IW ref: LT0594

RE: Whitegate-Aghada Waste Water Discharge Licence (D0423-02)

Whitegate Far Field Modelling Supplementary Report - Further DIN Modelling

Issue 2 | 5 July 2022

Figure 4 Existing, proposed and delta plots for the DIN Summer Scenario

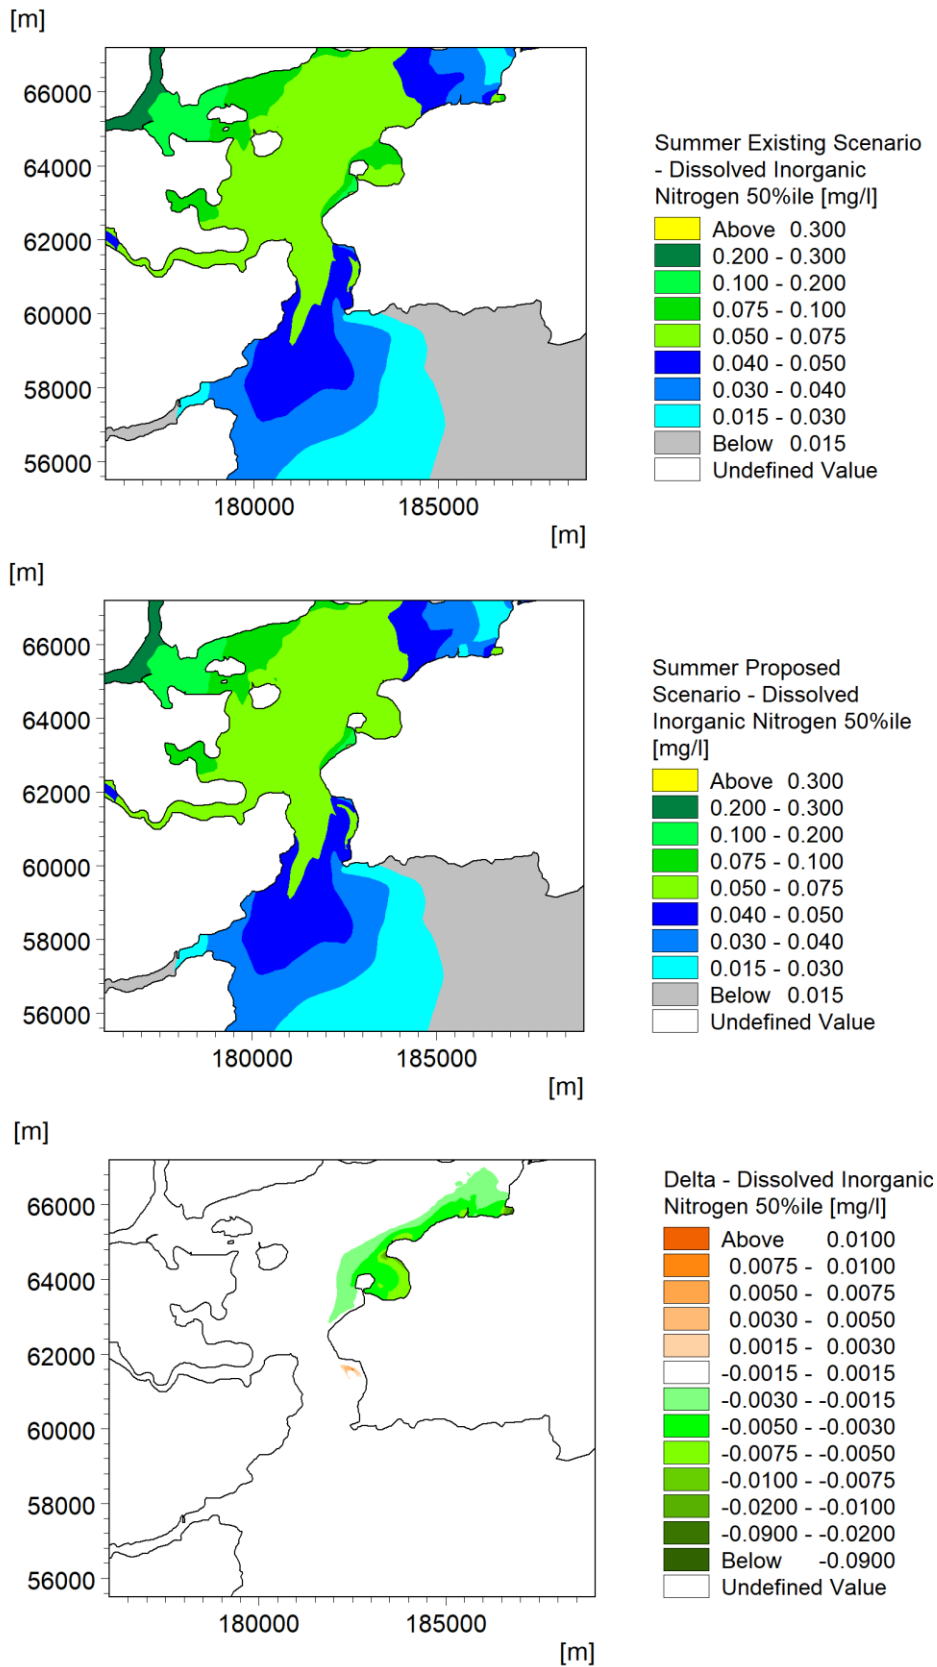
Provide an updated Marine Outfall Modelling Study which assesses winter and summer impacts from the worst case scenario of waste water discharges. In order to conclude that the Good Water Framework Directive (WFD) status of Outer Cork Harbour (WFD Code: IE_SW_050_0000) will be maintained and that the seasonal DIN EQSs will not be breached, the worst case winter and summer discharges must be assessed.

The spatially varying 50%ile DIN concentration plot for the Summer Scenario is presented in Figure 4. The 50%ile concentration at the individual monitoring points are presented in Table 4.

It can be seen from the results that the 50%ile concentrations of DIN in the area of the existing outfalls around Aghada are reduced with the scheme in place. There is an increase in concentration of circa 0.003 – 0.005mg/l in the immediate vicinity of the proposed outfall. This increase is deemed to be minor given that the limit of detection (LOD) for Ammonia is assumed to be 0.006mg/l.³

It can be seen from Figure 4 that the delta values at the EPA monitoring points all fall below the LOD (for Roches Point the delta equals the LOD). The differences are therefore deemed to be very minor and insignificant. It can also be seen from the table that the maximum 50%ile concentration at the EPA monitoring points is 0.057mg/l (Cork Estuary 2 point) for both the existing scenario and proposed scenarios. This is circa 0.26mg/l less than the DIN threshold for Summer. Good Indicative Quality is therefore maintained with the scheme in place.
